主旨: Fw: A/NE-TK/851 - 修改有關填土圖面

圖目 : Filling of Land

項目名稱 : 擬議臨時動物寄養所連附屬設施及相關的填土工程 (為期3年)

圖號 : Figure 2.5

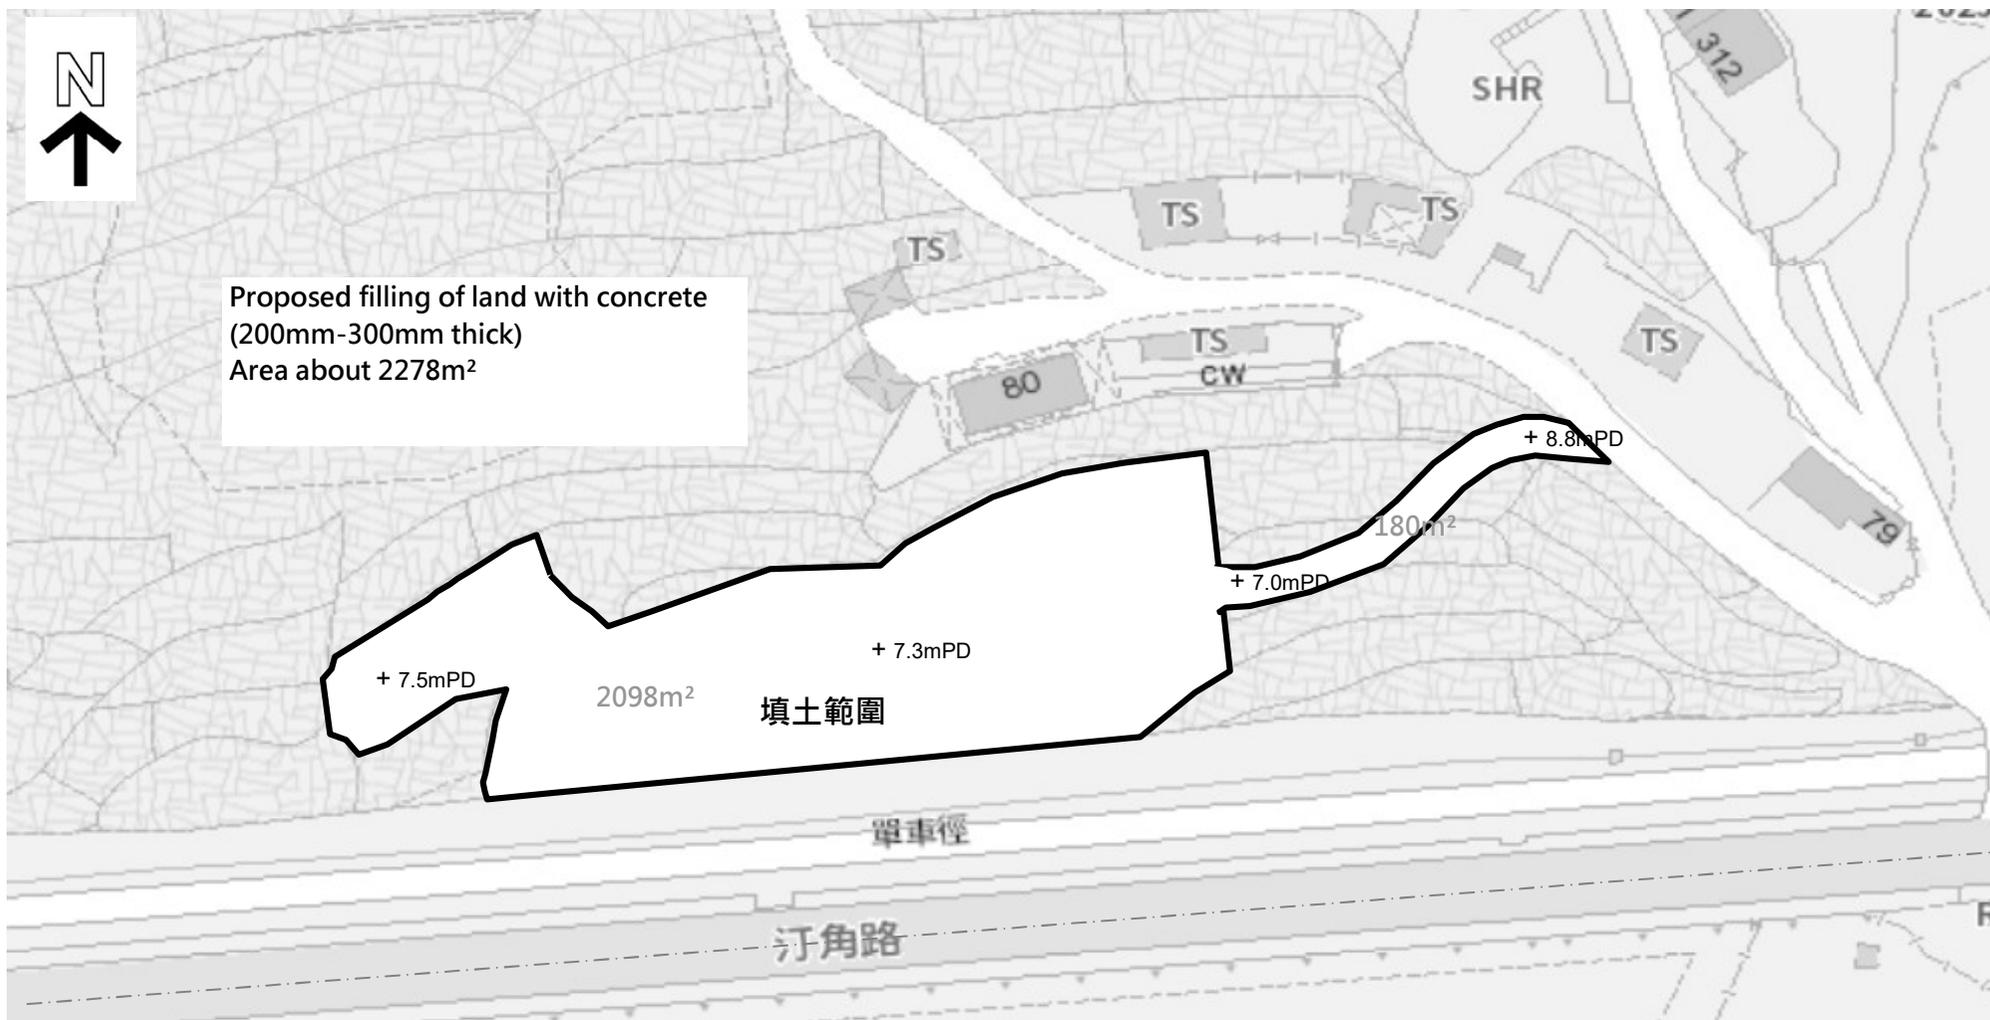
附件為修改後的填土圖 figure 2.5

- 1 有關規劃現場建議的路段上有一些貨櫃，這些貨櫃會在地盤平整時移走。
- 2 貨櫃A及貨櫃C之間的空地不會有任何構築物，日後主要用來遛狗（帶狗散步）。
- 3 除了建議的行車路段（閘門以外），申請場地日後會圍封。
- 4 建議行車的路段是向下斜落的，車輛是由上方斜落駛入場地。
- 5 有關申請場地及建議行車路段的座標水平請參考附圖（標示的座標為填石屎後的座標）
- 6 修改申請表第4頁（有關填土的厚度為0.2m-0.3m）
